SHOP DRAWING SUBMISSION FORM

Project	Proposed Residential Development at N.K.I.L. No. 6552, Kai Tak Area 4C, Site 2, Kai Tak, Kowloon
Works	Main Contract
Contract No.	19098KL
Ref. No.	19098KL / SS / AR - 004 / GC (Rev. 4)
Date	**06-Dec-2021**
To / Attn	Ronald Lu & Partners (Hong Kong) Ltd. / **Mr. Kelvin Ip/ Mr. Frederick Chan/ Ms. Magenta Kietkhajornsiri**
Subject	**Shop Drawing Submission of Curtain Wall (Tower)**
Anticipated date of response	**13-Dec-2021**

RESPONSE TO SHOP DRAWING SUBMISSION

01/1001 TOWER 1, 2 AND 3 TYPICAL FLOOR FRAMING PLAN FOR CURTAIN WALL(2/F - 32/F PLAN 27 STOREYS)

TITLE :
PARTIAL ELEVATION, PLAN, SECTION FOR TOWER 2&1

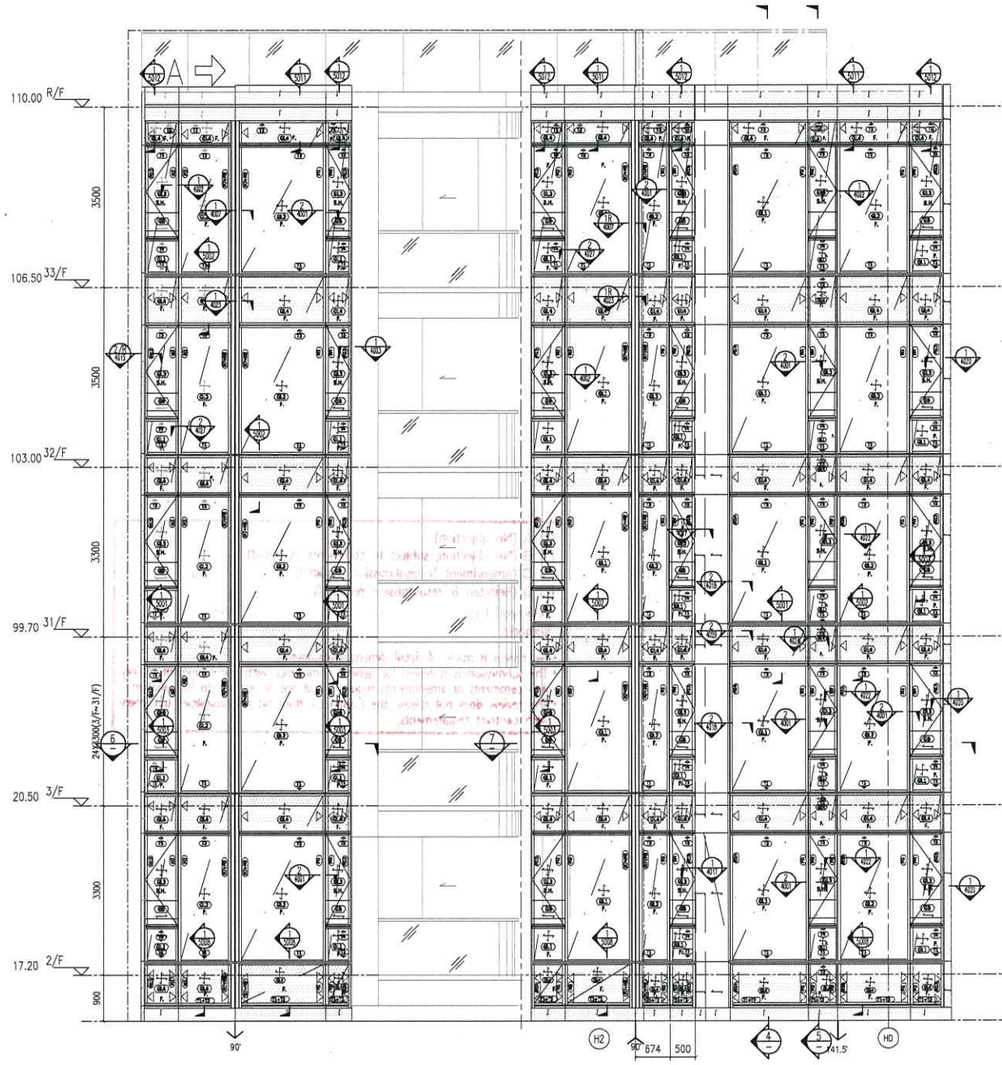
A VERTICAL SETTING-OUT FOLLOWS COMMENT ON PE-3001.

PARTIAL ELEVATION, PLAN, SECTION FOR TOWER 6

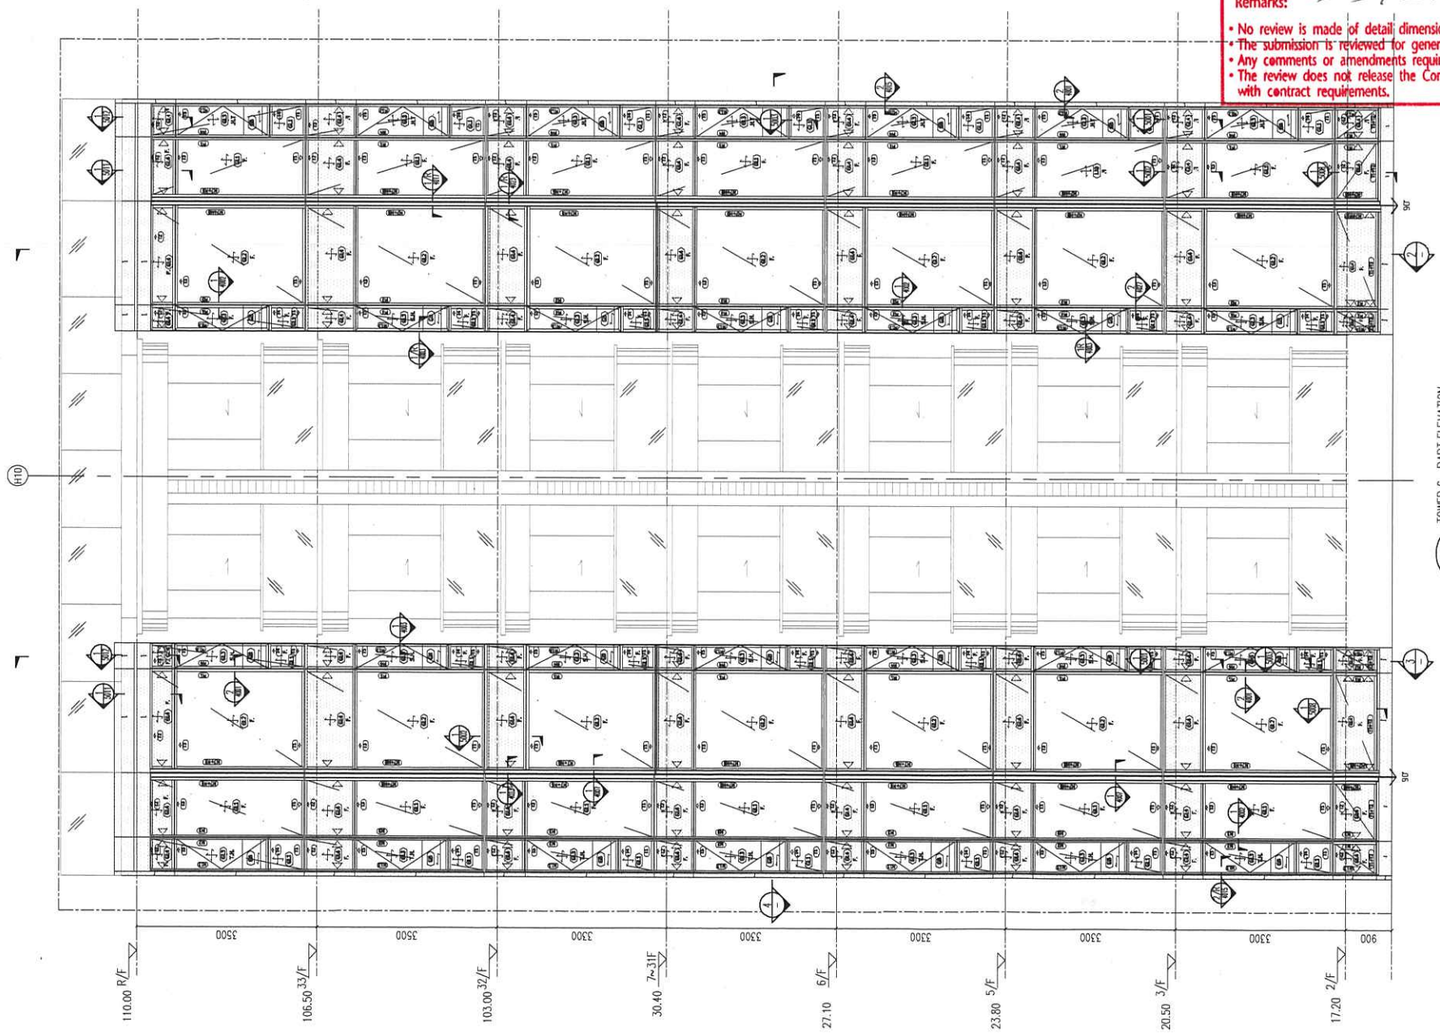
Vertical setting-out Engineer's comment to PE-3019

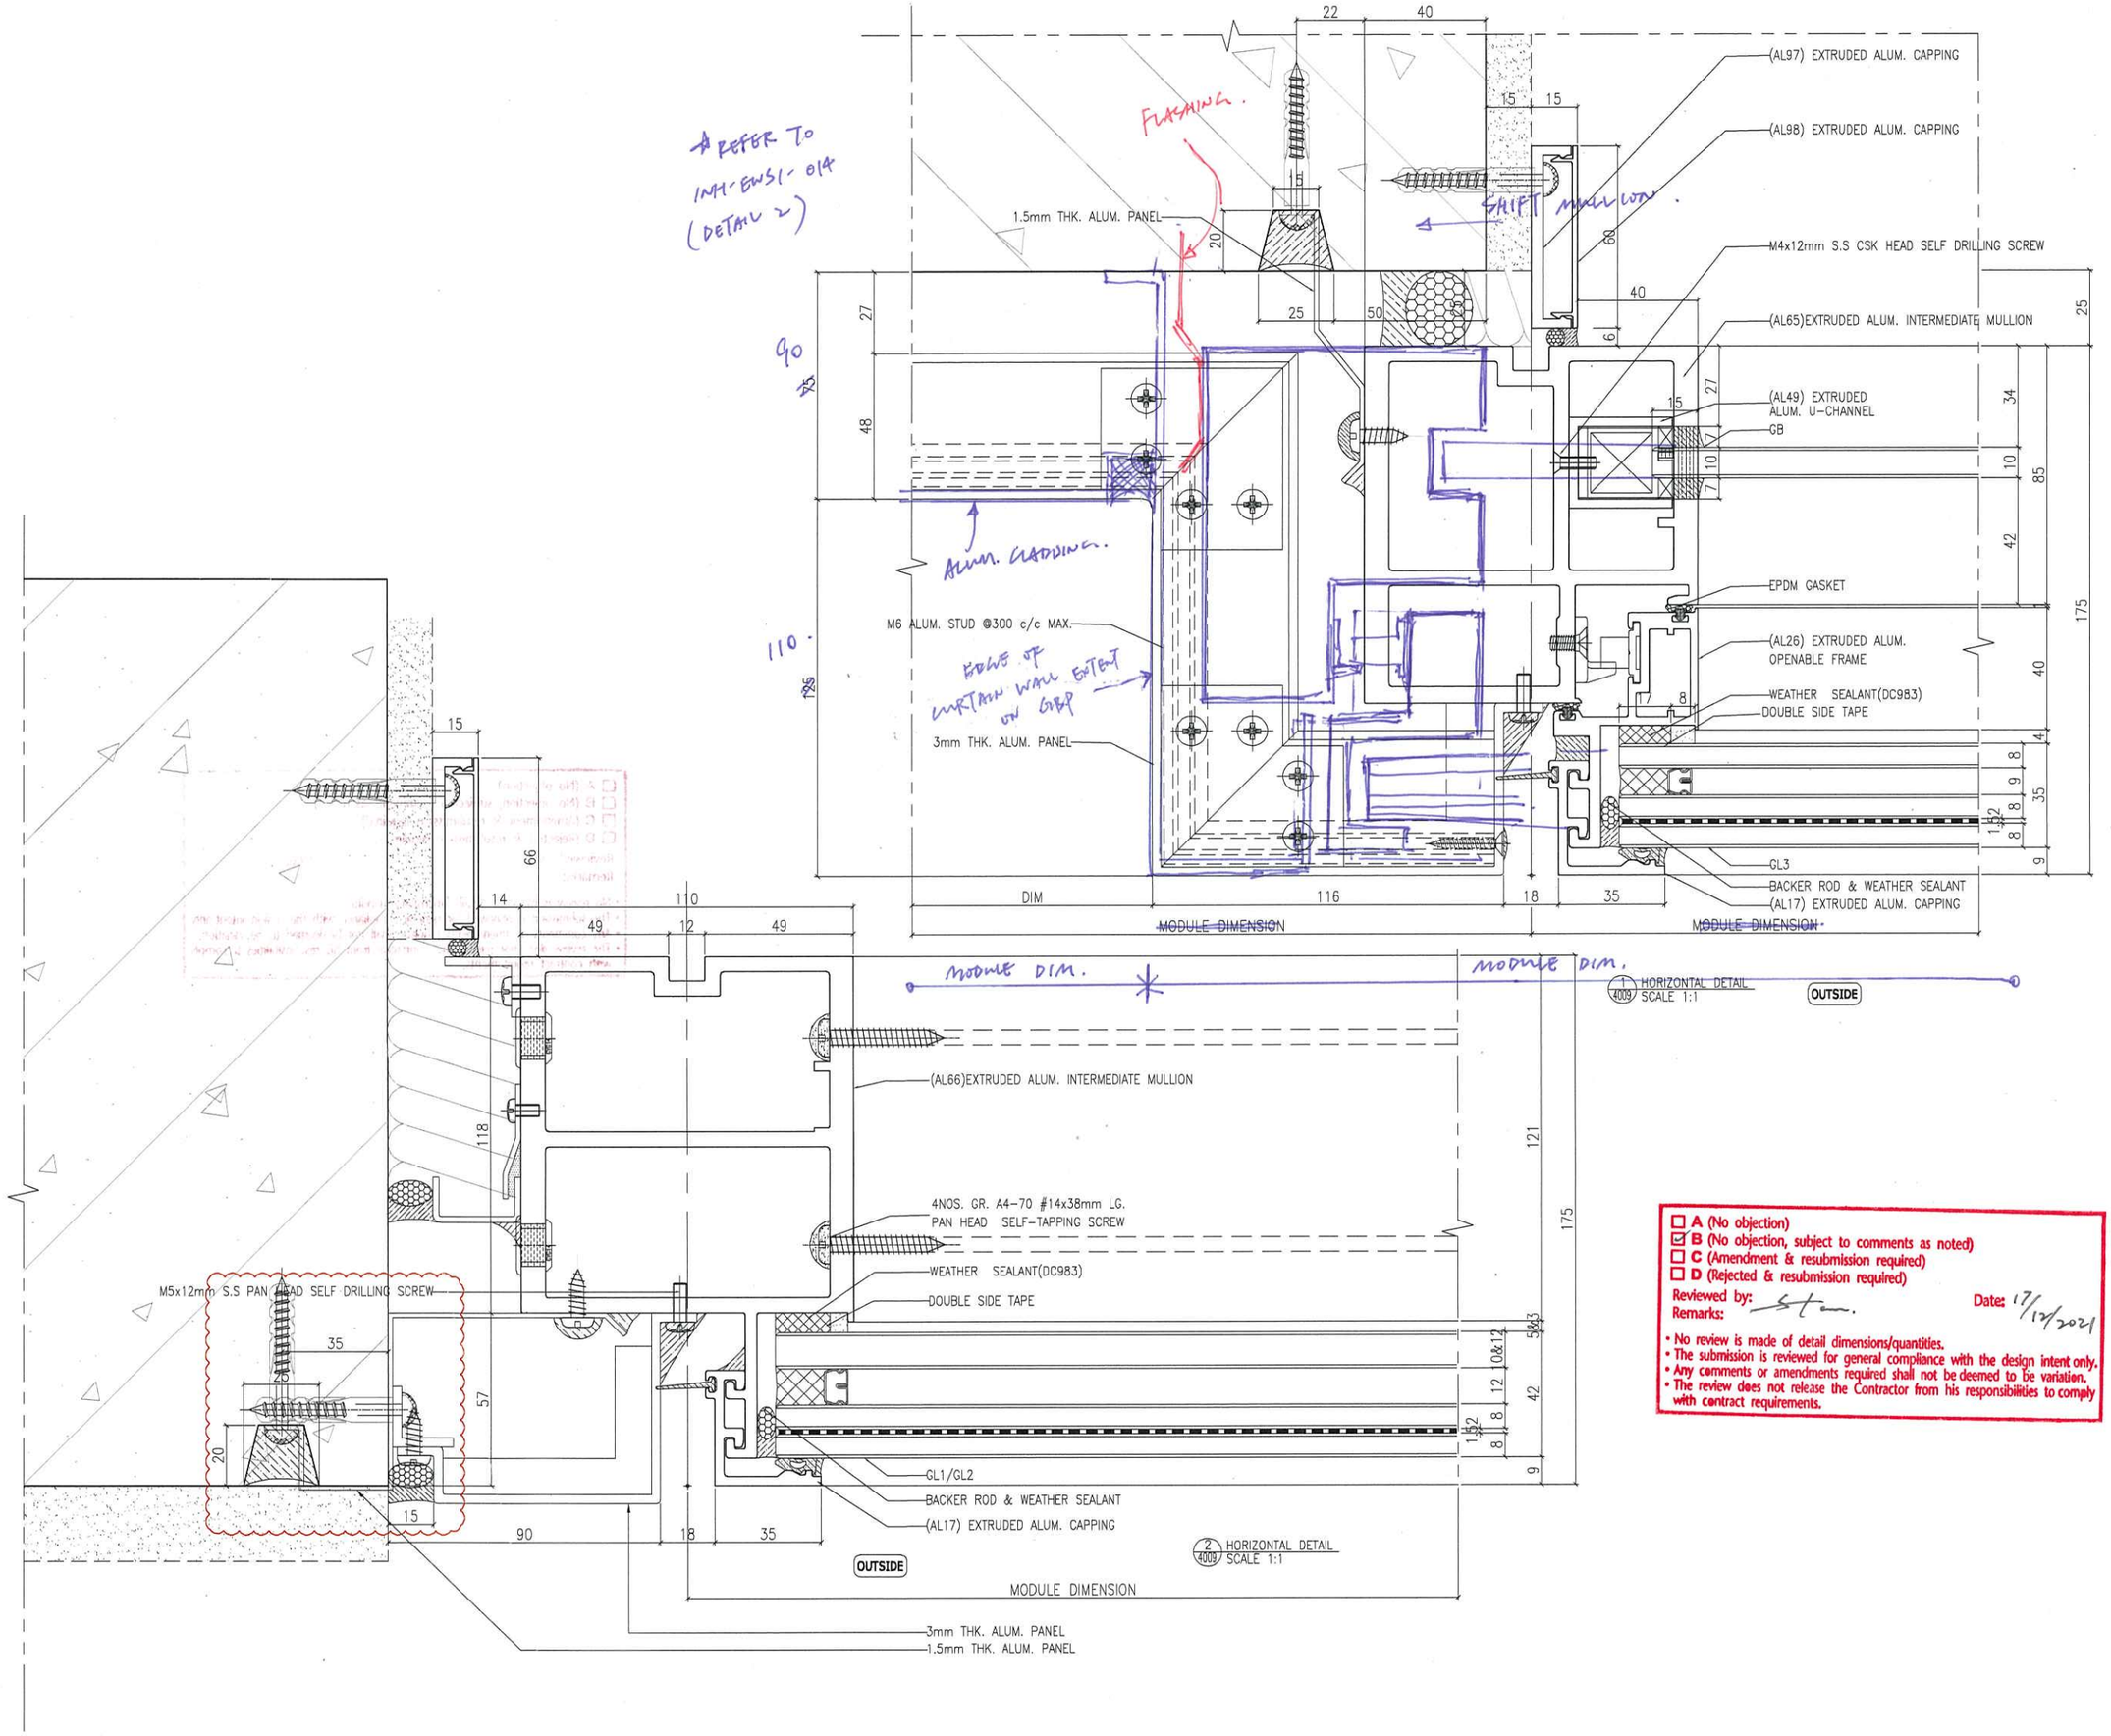
A REFER TO INH-EWS1-01A (DETAIL 2)

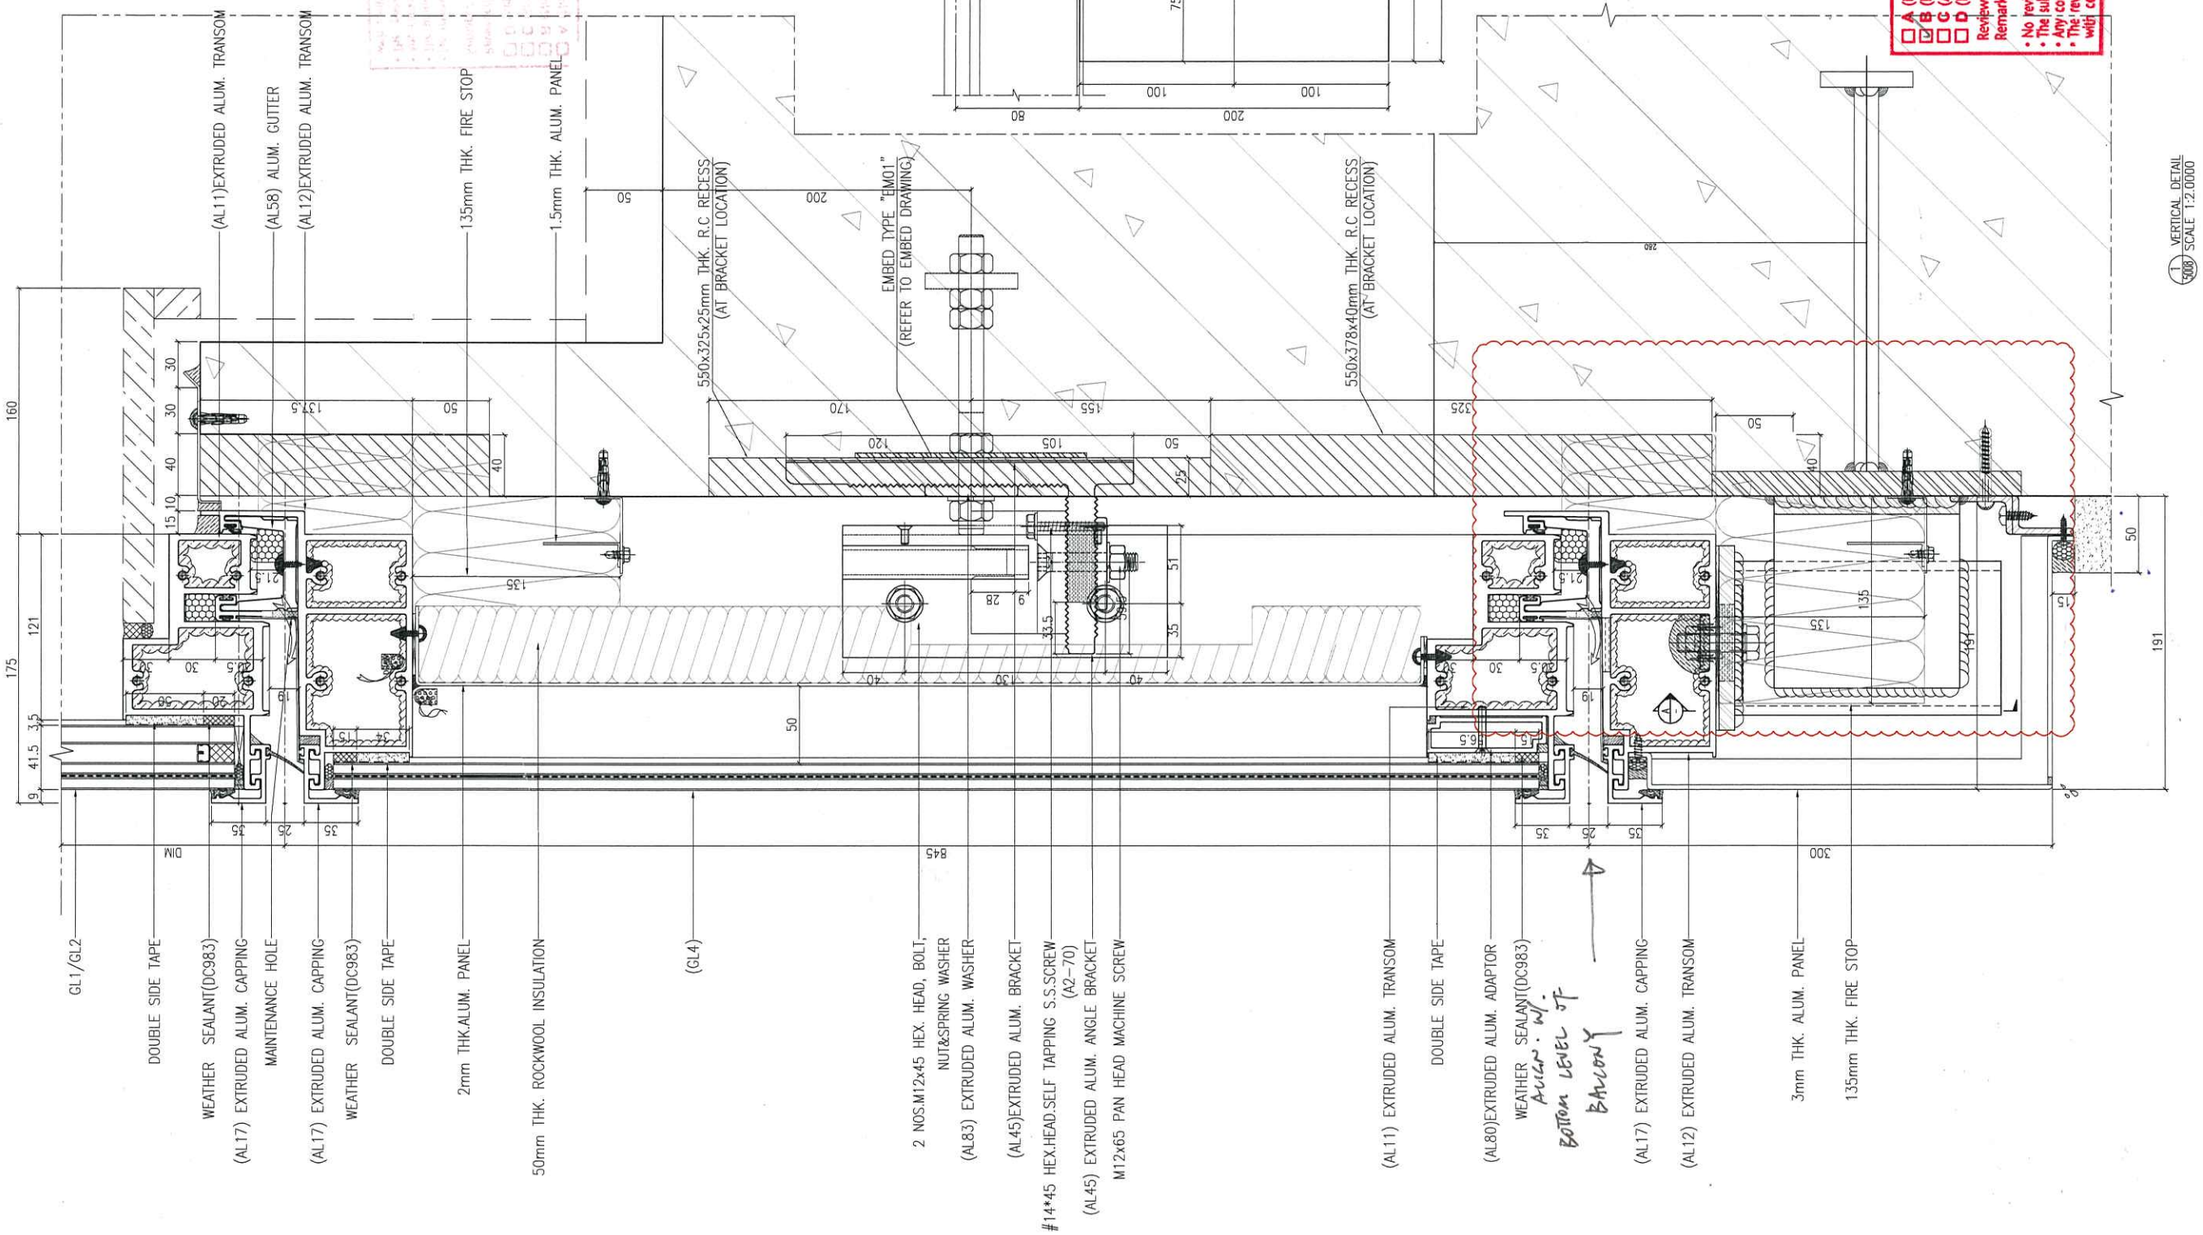
A INTERFACING DETAIL AT TRANSFER PLATE
SUBJECT TO CONFIRMATION OF
TRANSFER PLATE EXTENT

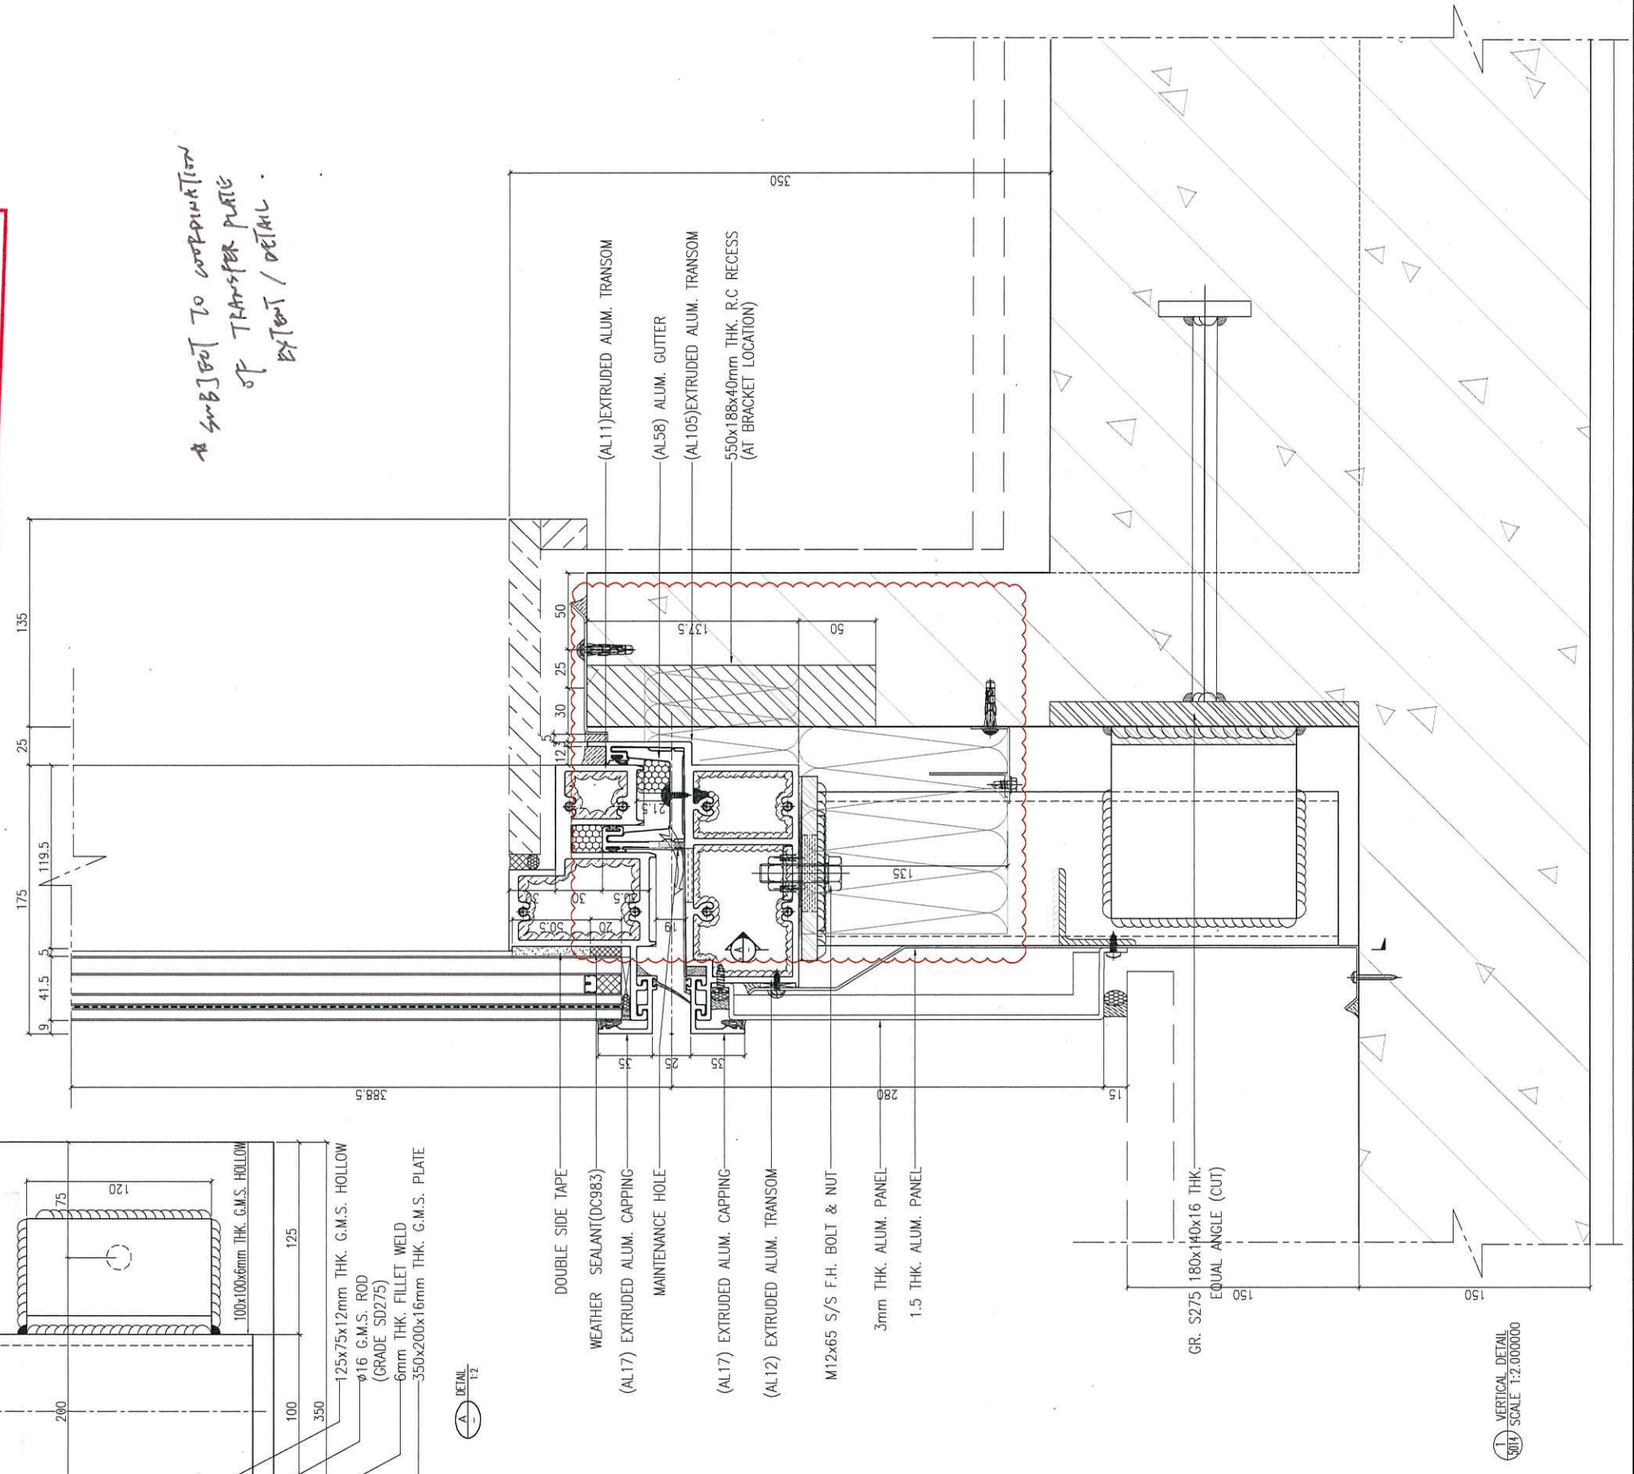
* SUBJECT TO COMFIRMATION OF TRANSFER PLATE EXTENT / DETAIL.
